## **K. FIRE**

**FIRE FLOW CALCULATIONS**  
**Lincoln Street Apartments**

**Project Name:** 9 Unit Townhomes  
**Project Address:** 2420 Lincoln Street  
Hollywood, FL  
**ZE Project #: 23-04**

**RE: Landscape Comment Responses  
9 Unit Townhomes – 2420 Lincoln Street  
Hollywood, FL 33020**

C5

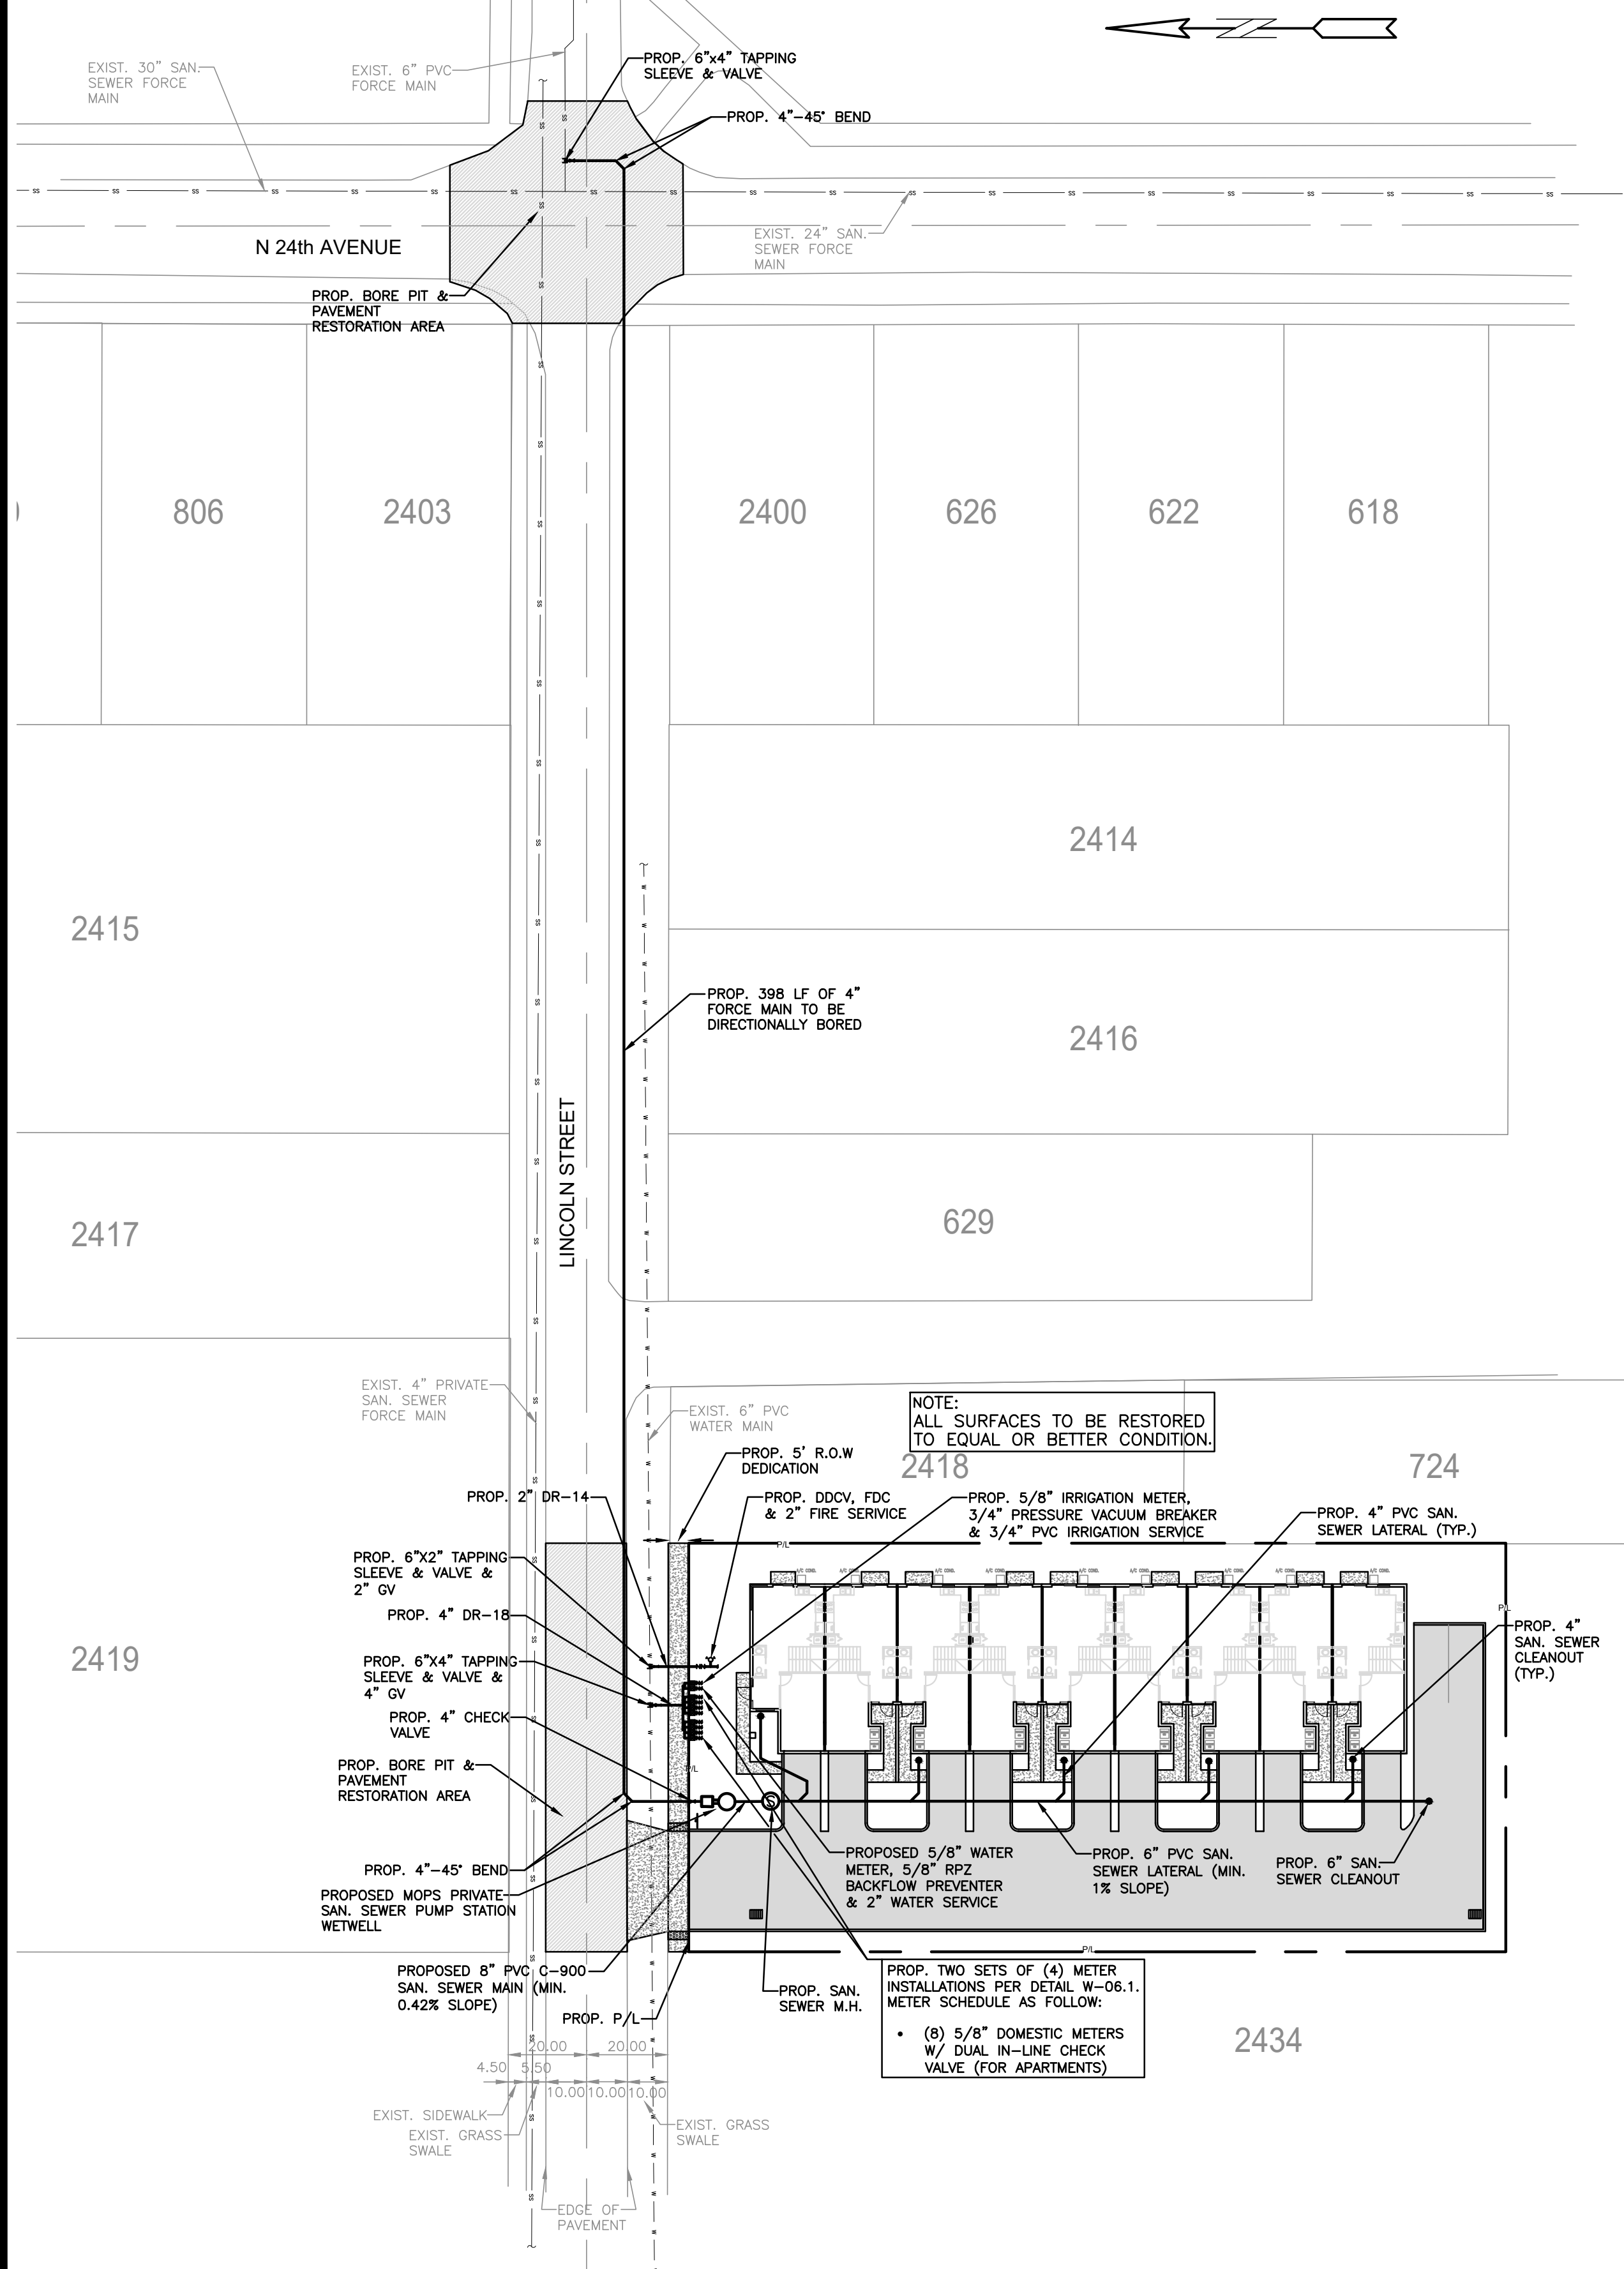
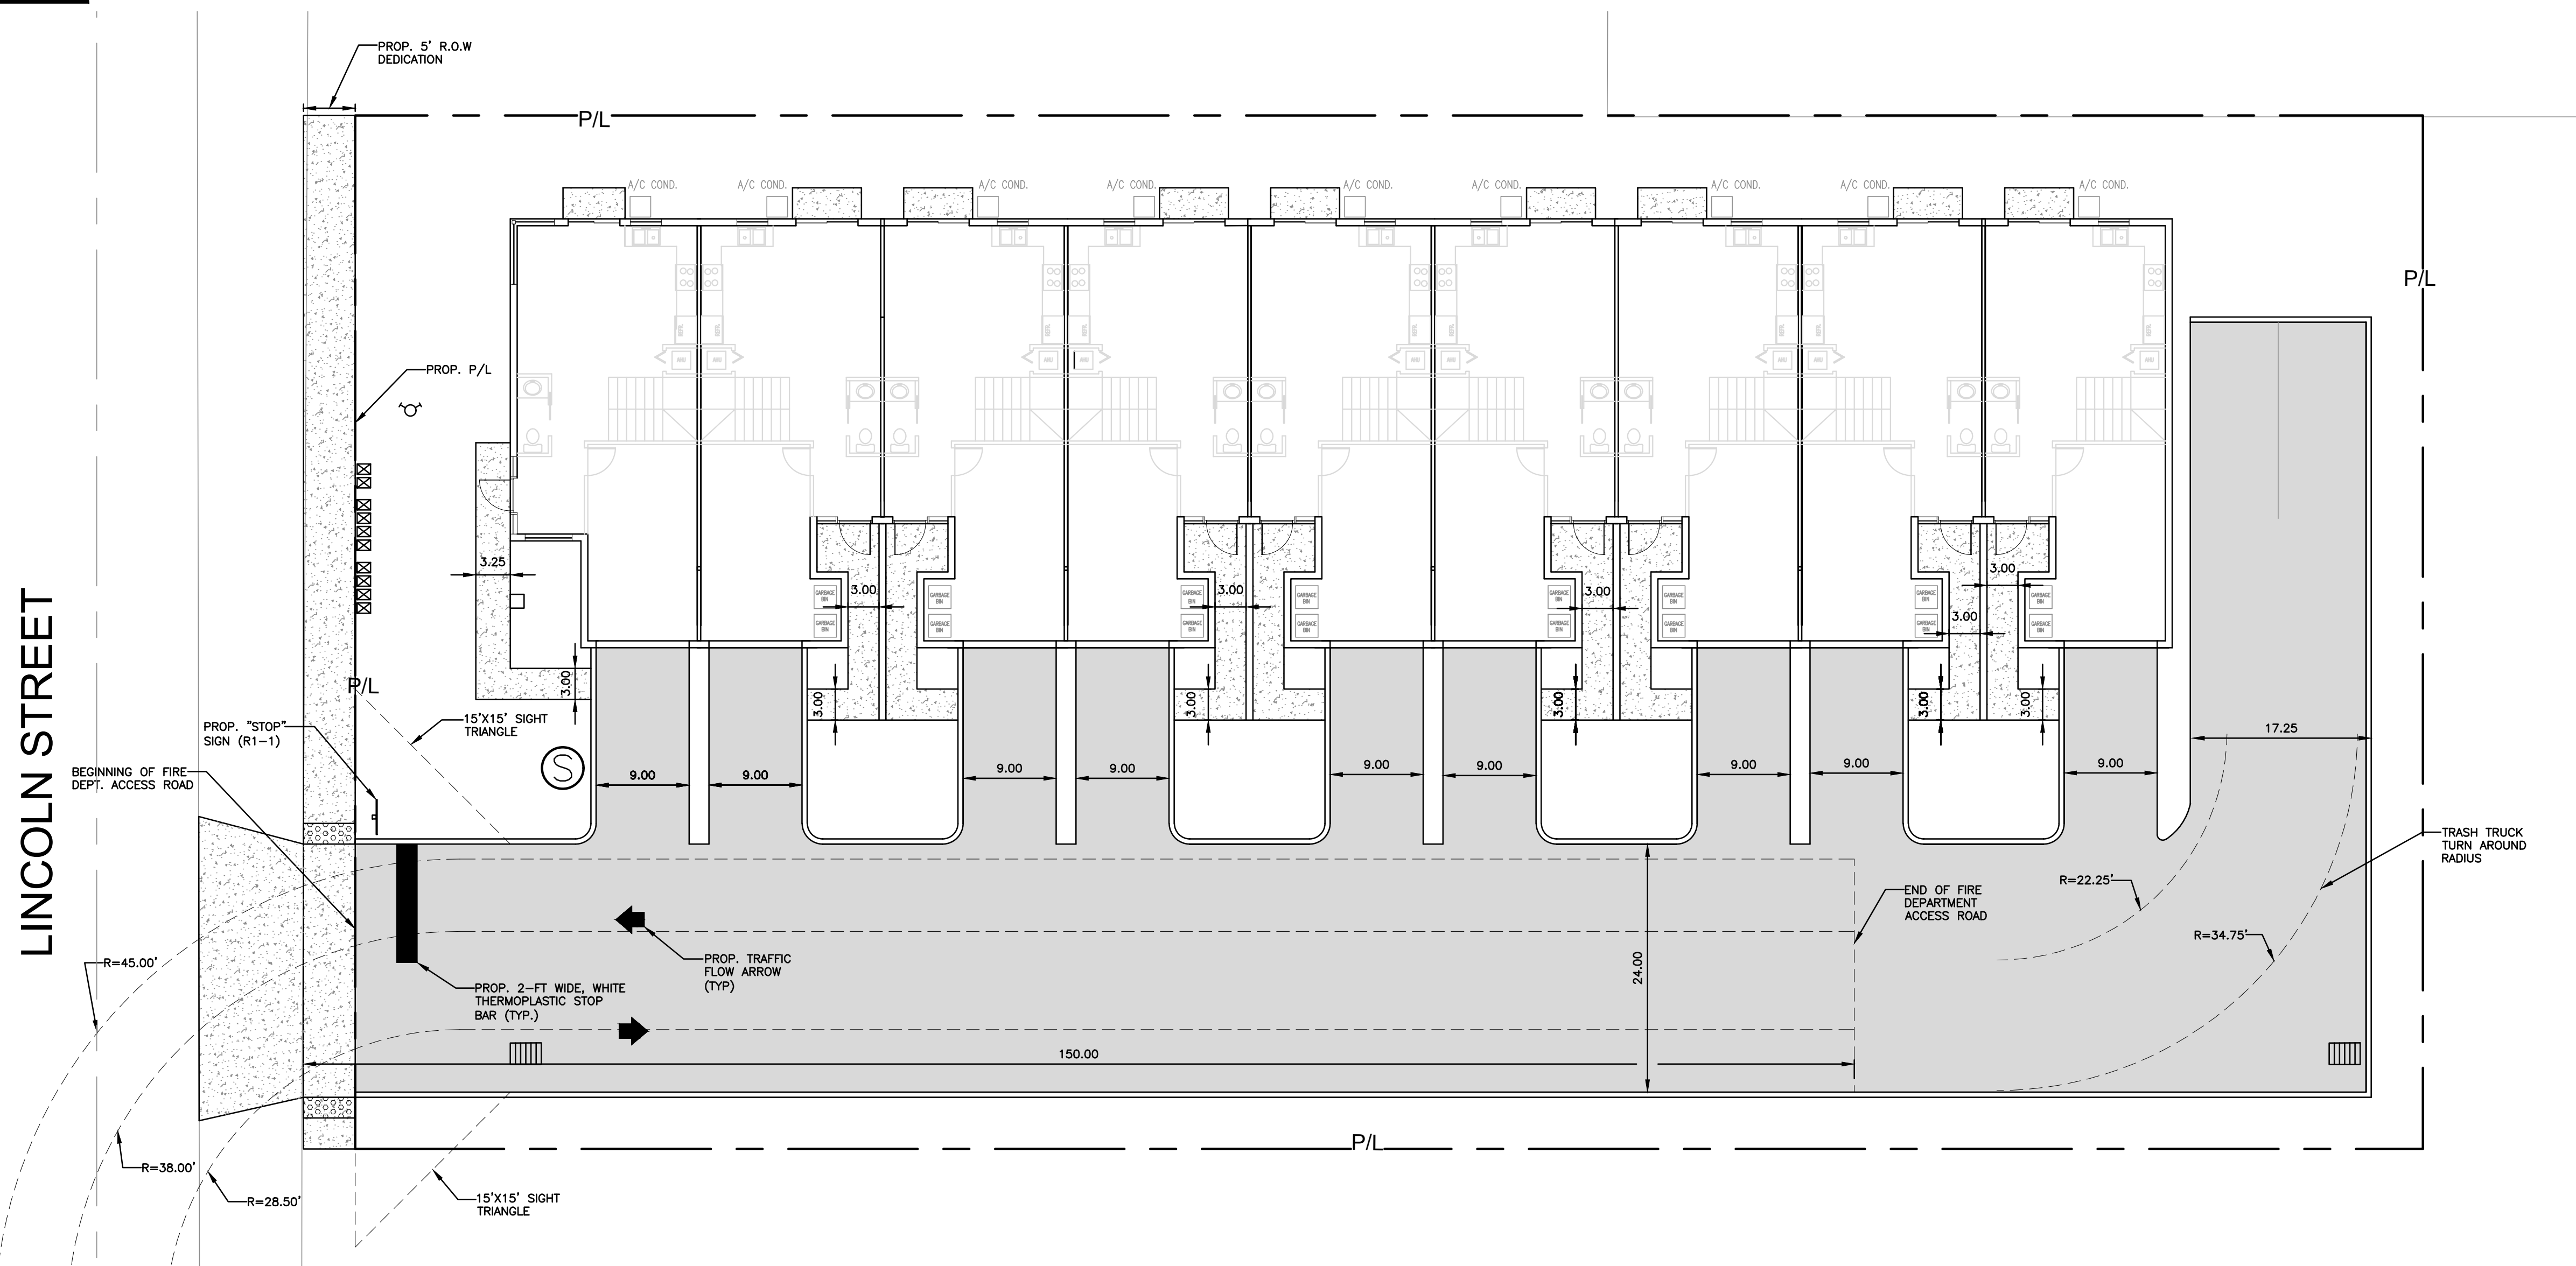
2. As per NFPA 1 (2018 Ed.) Section 18.2.3.2.1 --- A fire department access road shall extend to within 50 ft. (15 m) of at least one exterior door that can be opened from the outside and that provides access to the interior of the building. As these are townhomes separated by firewalls, then the front door to each townhome shall be considered within the distance measurements. --- Show this on the plans.

4. As per NFPA 1 (2018 Ed.) Section 18.2.3.5.4 (Dead Ends) --- Dead-end fire department access roads in excess of 150 ft. (46 m) in length shall be provided with approved provisions for the fire apparatus to turn around. --- Diagrams of acceptable methods attached.

5. When submitting plans, they must show fire department access roads along with the required turning radii. --- The minimum width for FD access roads is 20' unobstructed as per NFPA 1:18.2.3.5.1.1, per 18.2.3.5.1.2, fire department access roads shall have an unobstructed vertical clearance of not less than 13 ft. 6 in. (4.1 m) and per 18.2.3.5.3.1, the turning radius for fire truck access: 28'.5" interior radius, 38' centerline of the turning radius, and 45' exterior.

**RESPONSE: Please see fire department access dimensions on sheet C5.**

**RESPONSE: Please see fire department access dimensions on sheet C5.**

**RESPONSE: Please see fire department access dimensions on sheet C5.**
